Re: Georges Cove Marina at 146 Newbridge Road, Moorebank - Response to TfNSW matters

This letter responds to the traffic related matters that have been raised by Transport for NSW (TfNSW) in their letter dated 30 March 2020 for the Georges Cove Marina (TfNSW Ref: SYD18/01728/04, Council Ref: DA-611/2018).

Approved Line Marking Plans

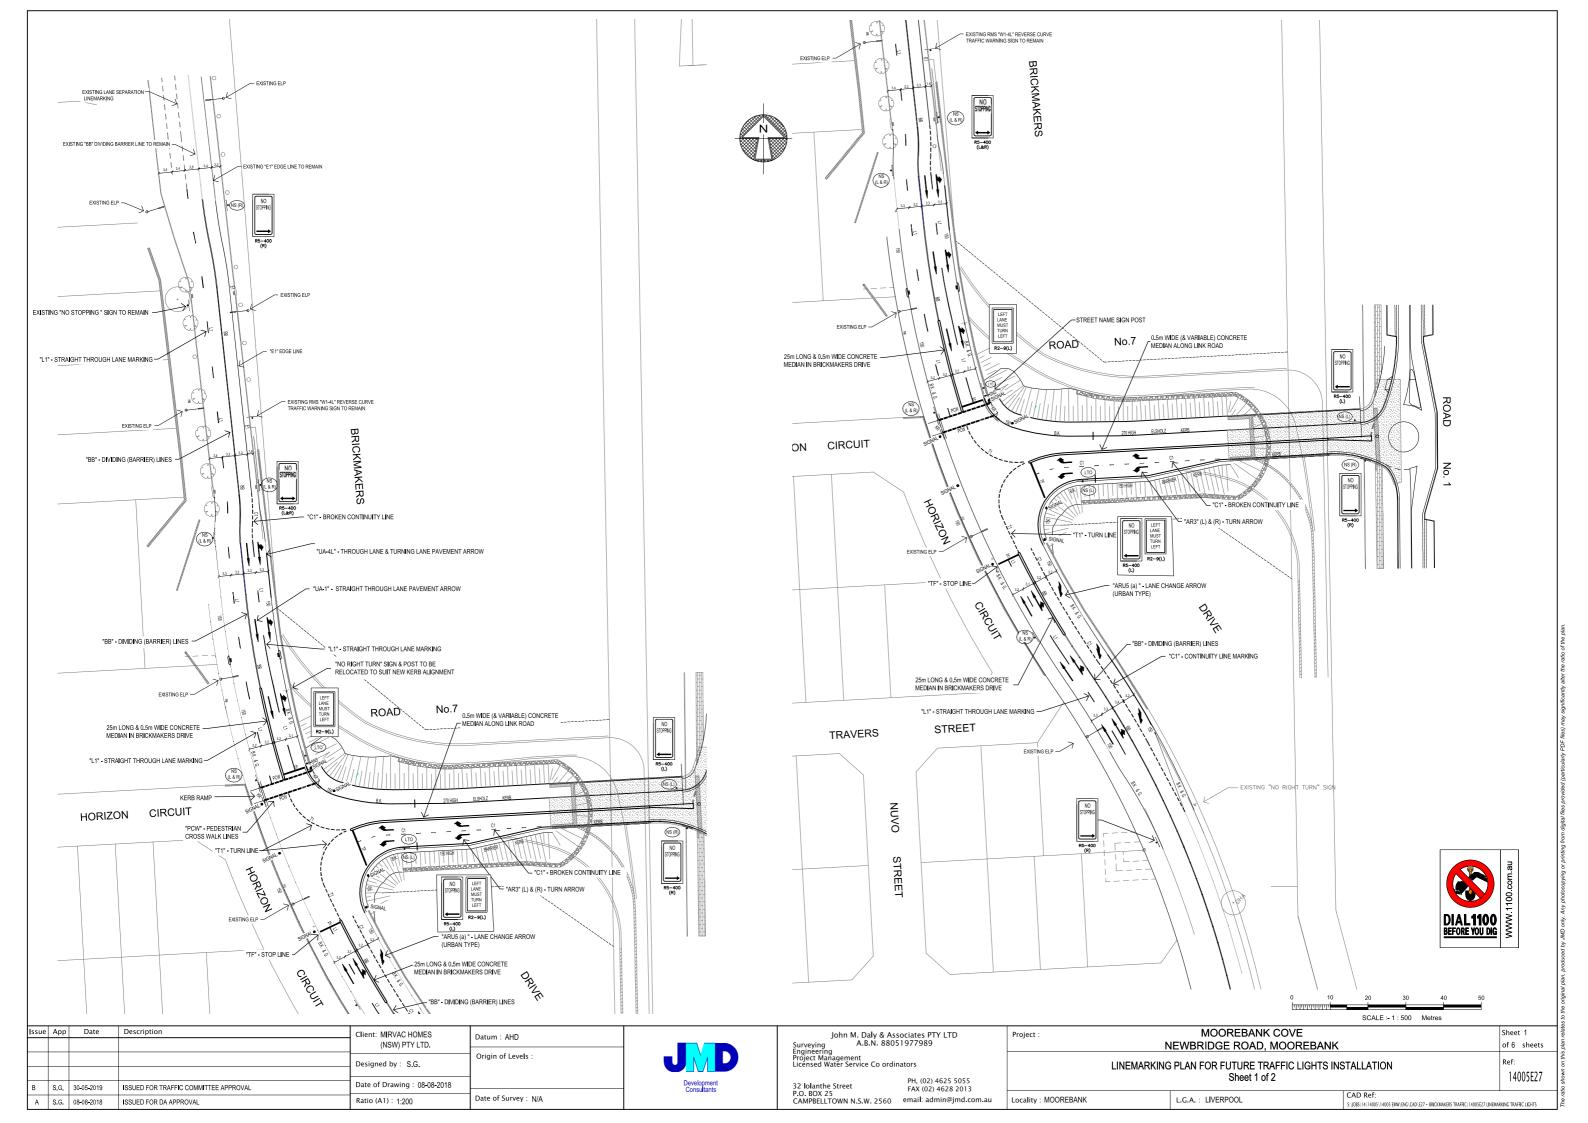
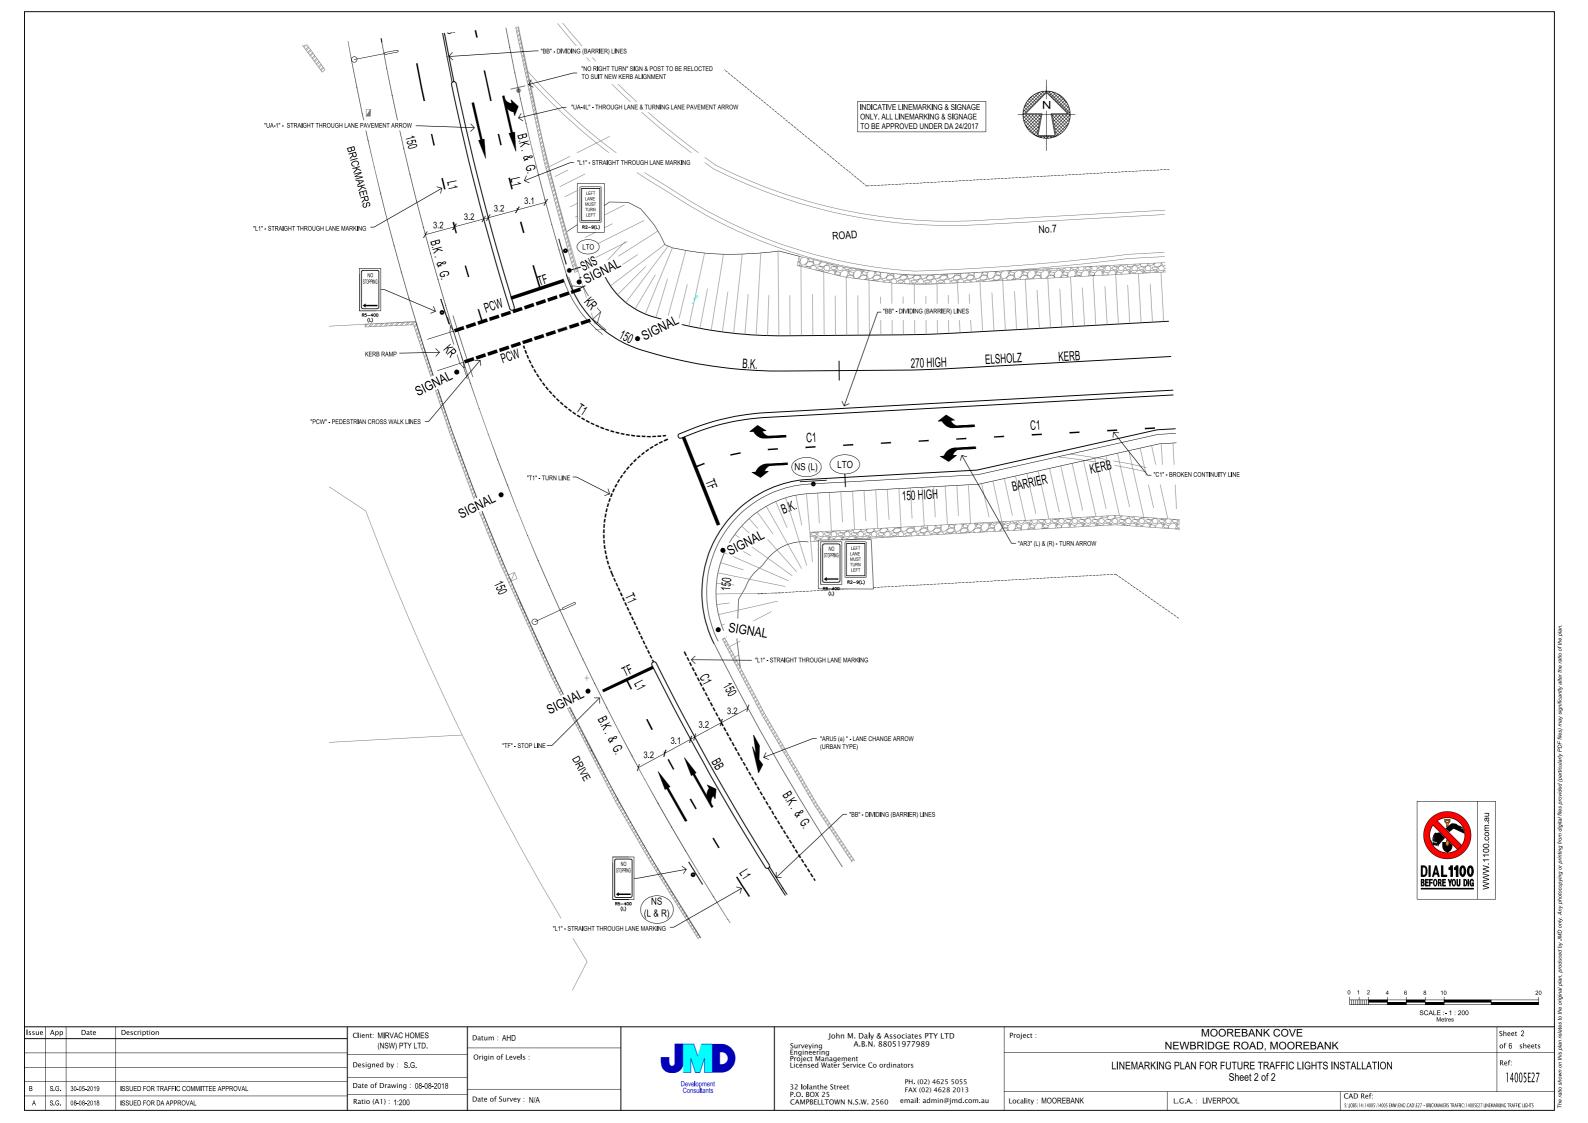
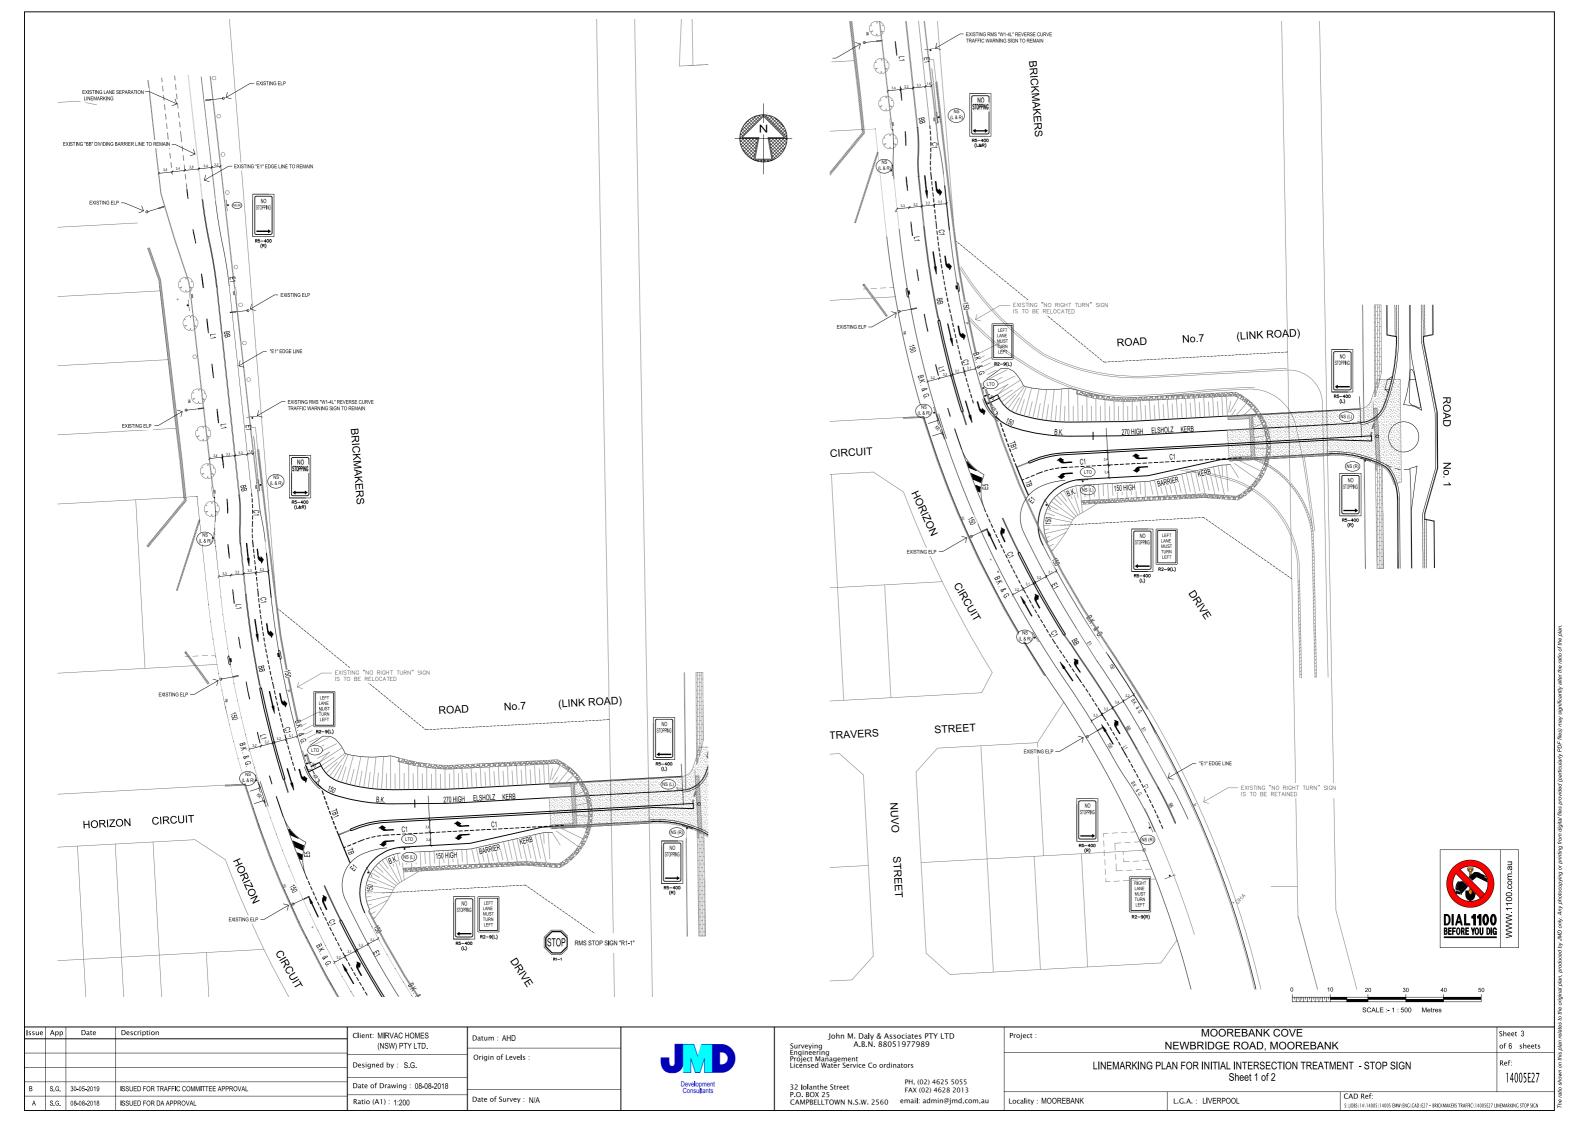
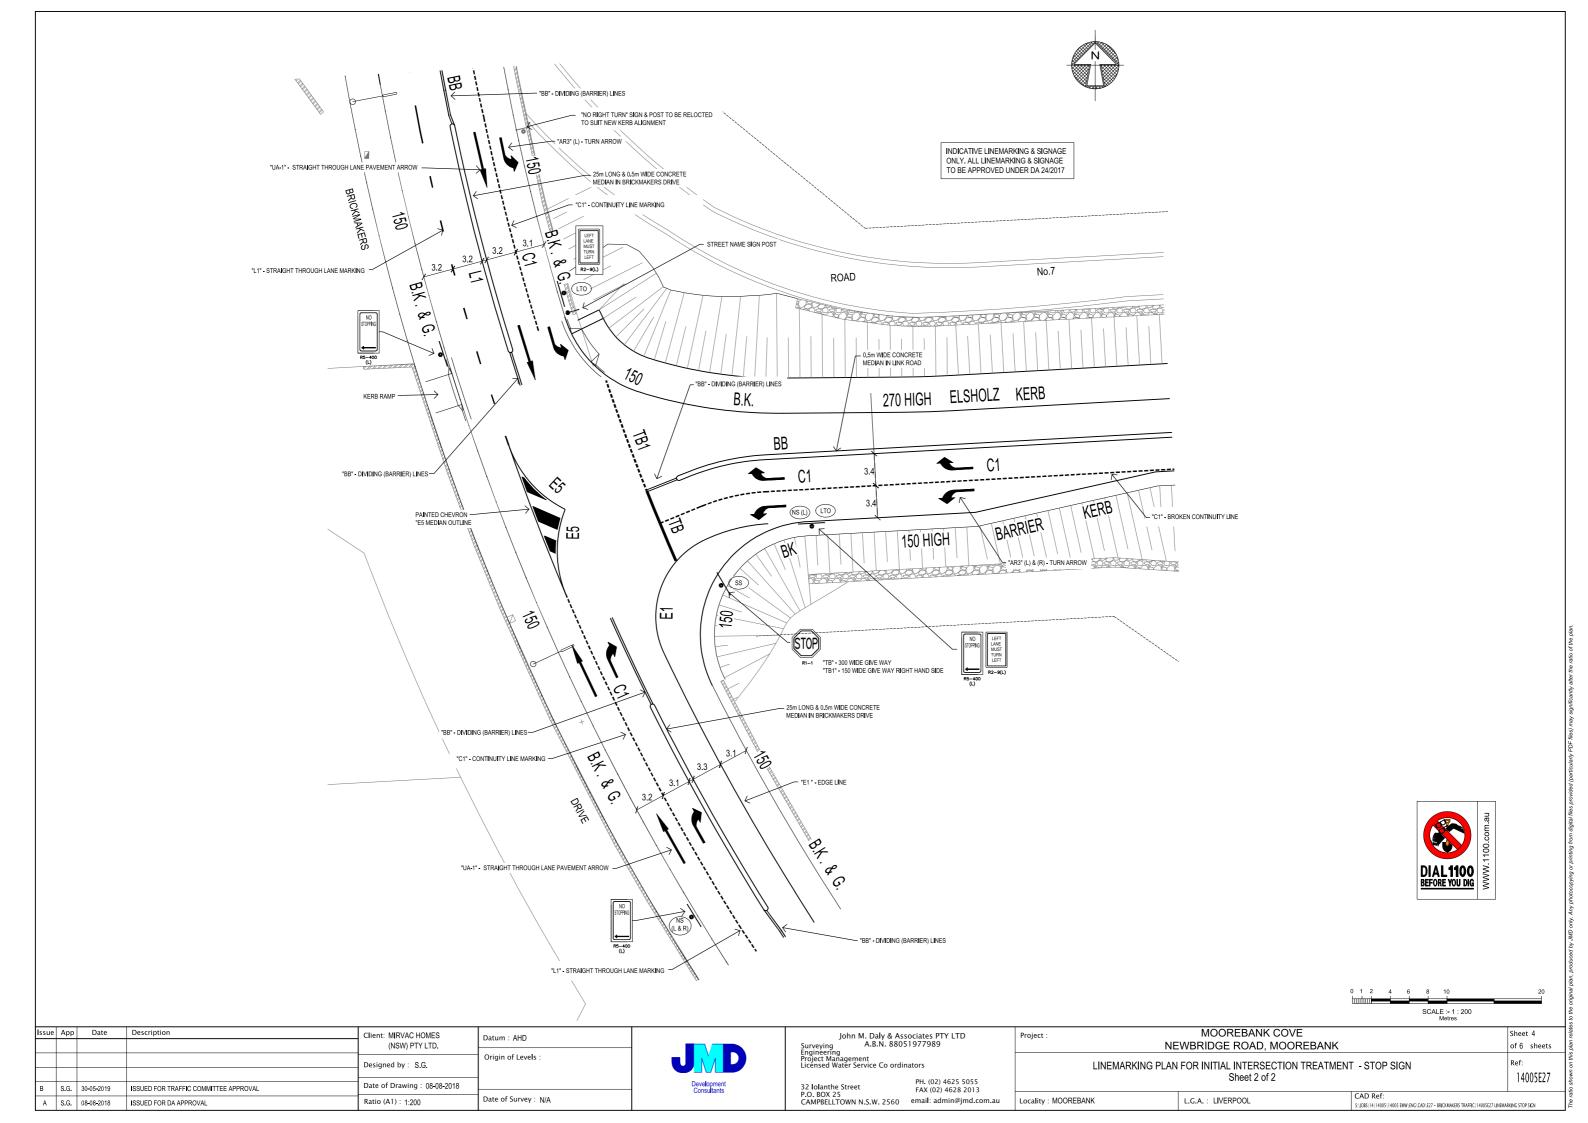
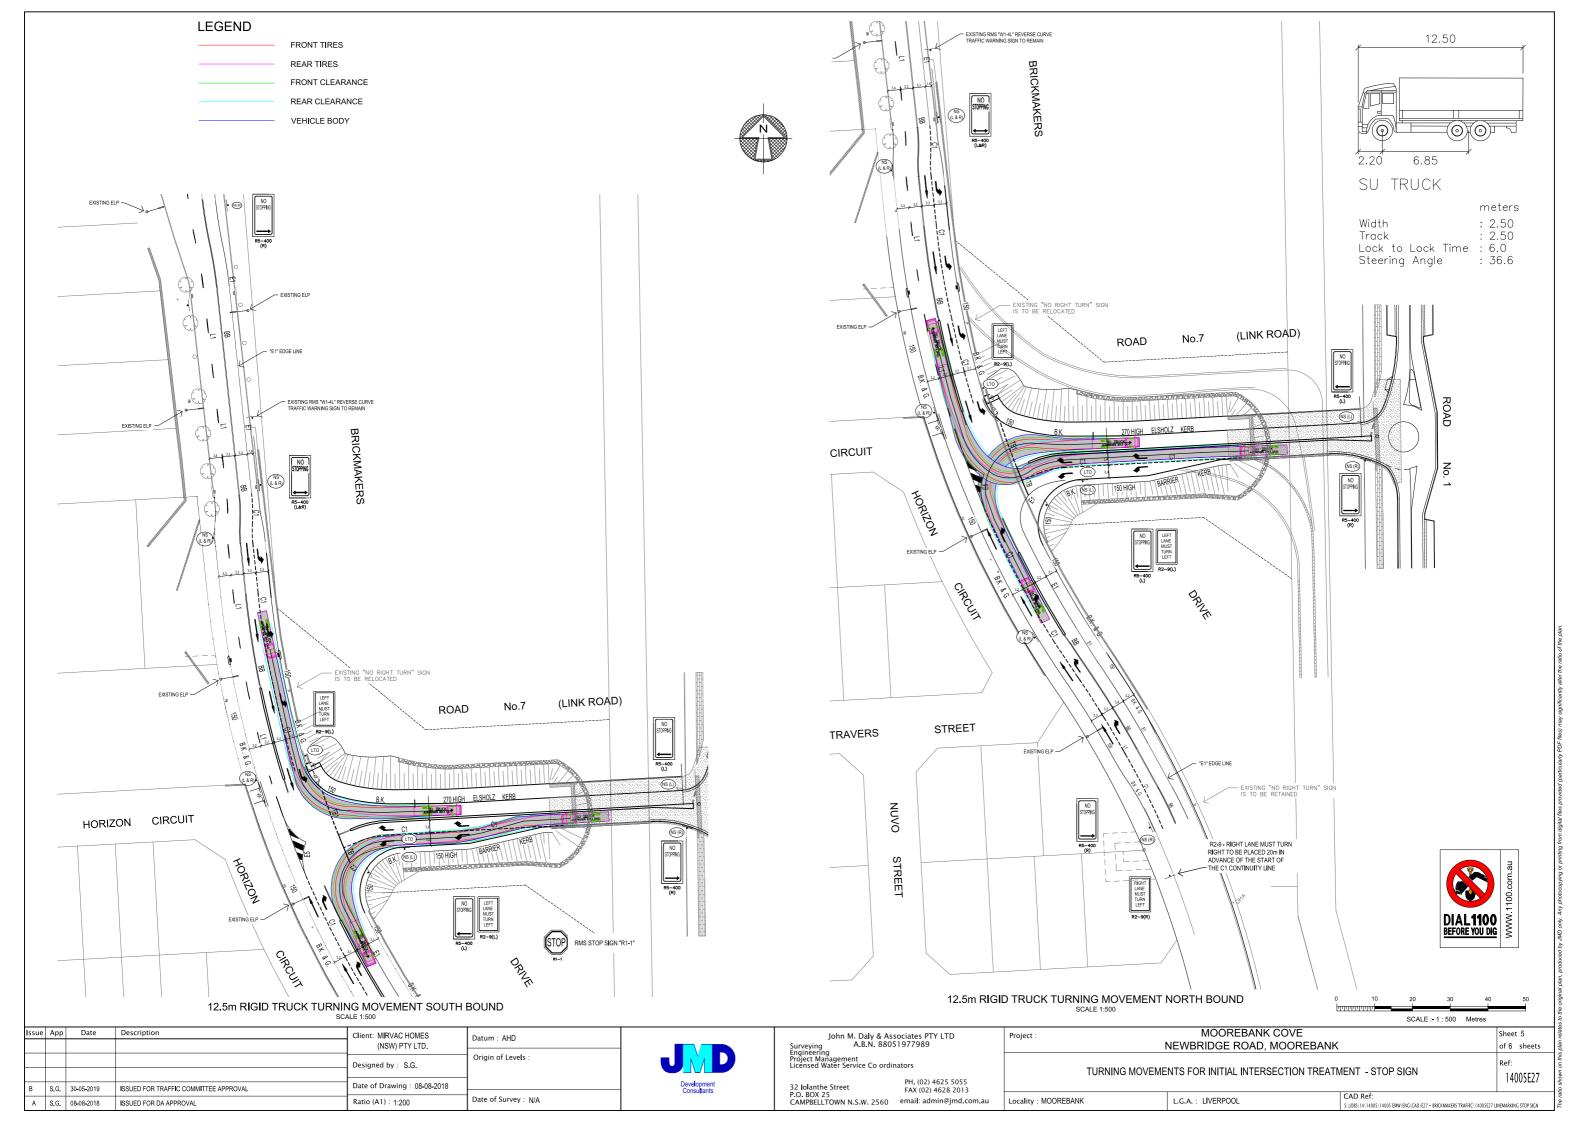
The signalized intersection layout shown on Figure 11 provides two right turn lanes on the Link Road, but only one through lane on the northern leg on Brickmakers Drive. It is not possible for vehicles to merge within the signalized intersection and this layout needs to be amended accordingly. Also it is not clear why there is a 60m long acceleration/merge lane on the southern leg for the single through lane on the northern leg on Brickmakers Drive.

The Liverpool traffic committee has approved the line marking plan for the Brickmakers Drive/Link Road intersection as a priority-controlled intersection, refer Appendix E and Appendix F.

The priority-controlled intersection has been designed so that minimal civil work will be required when the intersection is signalised. This has been discussed at the traffic committee.

The kerbside lane in Link Road could be converted to a combined left and right turn lane to increase the capacity of this intersection as most of the traffic will exit to the north from Georges Cove marina precinct. On the south approach, the 60 long merging lane is provided on the interim layout which could be adjusted as part of the signalisation process in due course. After the TfNSW's in principle approval of the traffic signal at this intersection, a traffic signal plan (TCS) will be prepared for TfNSW consideration. In the traffic signal design, this merge lane could be excluded if it is considered unnecessary. Hence, this merge lane could be retained in the interim giveway controlled intersection as it is already approved by the Liverpool traffic committee.
